LAA/AWA/13/07  
11<sup>th</sup> October 2013

## Rotax 912 and 914 (Series) Engines Checking of the Crankshaft Journal

Fig. 1. Crankshaft Journal  
Rotax Aircraft Engines.

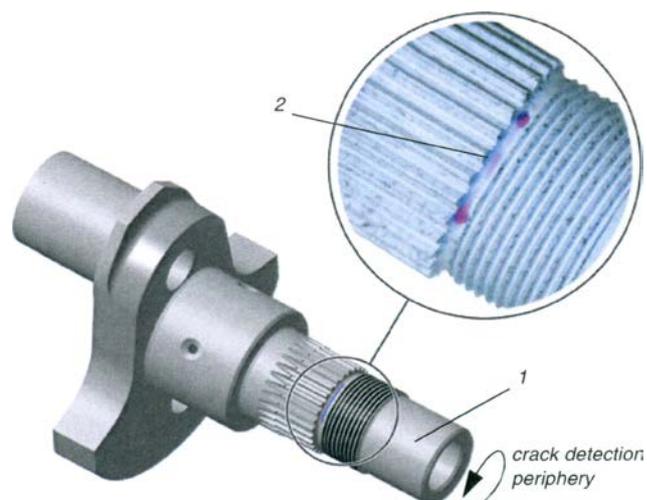
Fig. 1 (opposite) shows a sketch of the area of concern, item 1 shows the crankshaft journal itself, this bearing face sits securely in the gearbox housing. Item 2 shows a small crack in the radius between the splined power take off and the journal. It can be seen that drive to the propeller would not be lost if this crack progressed to a complete failure of the shaft as the gear is driven through the parallel spines although, naturally, some radial support would be lost in the crankshaft assembly should separation occur. Rotax engineers have determined that, in the event of complete failure, engine operational reliability is assured until the next maintenance check.

Fig. 2. Feeler Gauge to check crankshaft security.  
(Note: Gearbox removed for clarity)  
Rotax Aircraft Engines.

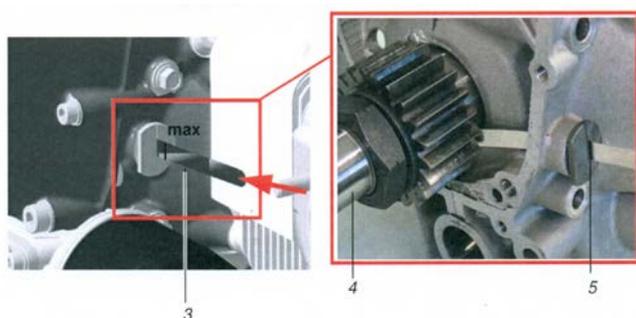
Fig. 2. (opposite) shows a picture of the new repetitive check required on affected engines; a special tool is required to carry out this check. Checks need to be carried out each 100 hours (or annually).

In basic terms, a pre-marked feeler gauge (3) is inserted through a guide pin (5) until it abuts the main crankshaft journal then, with a slightly elevated force, the pinion gear will be contacted. Increasing pressure on the feeler may move (very slightly) the gear on the spline; if the crankshaft is intact then the mark on the feeler will remain outside the housing.
